POWER-SUPPLY CAPS

LETTERS

FIGURE 1: Panasonic 120 μ F/25V HFQ and FC characteristics. Z (ohms) versus frequency (Hz).

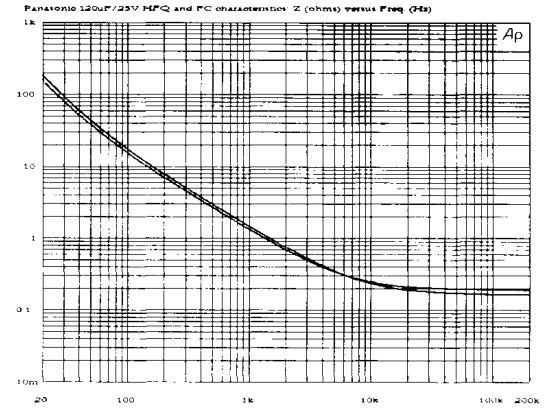
Some actual measured data for HFQ and FC 120 μ F/25V types is also useful for further perspective (this value/voltage isn't covered by the table, due to nonavailability in the FA family). This particular value/voltage has been used in past TAA projects, and illustrates a couple of points.

Figure 1 shows measured impedance curves for HFQ and FC types, over a range of 20Hz to 200kHz. The measured 100kHz ESR is 180 Ω and 200m Ω , respectively, both less than HFQ and FC specifications of 200 and 250m Ω . Although the differences aren't huge, in this value/voltage, the HFQ type would actually be preferred in performance terms. Figure 2 shows what can be done to lower ESR with three parallel FC 120 μ F/25V units. The 70m Ω 100kHz ESR compares favorably with 330 μ F/25V single units above.

Some unfortunate errors crept into my letter entitled "RE-CAP" (*AE* 3/99, p. 40). In the last full paragraph in the first column, the second sentence referencing measured 100kHz ESR should read "... 100kHz ESR is 180 and 200m Ω , respectively, ..." In the table at the bottom right of the same page, the first capacitor value/voltage column should be labeled "330 μ F/25V." All of the tabular data presented is in terms of 100kHz ESR (in m Ω).
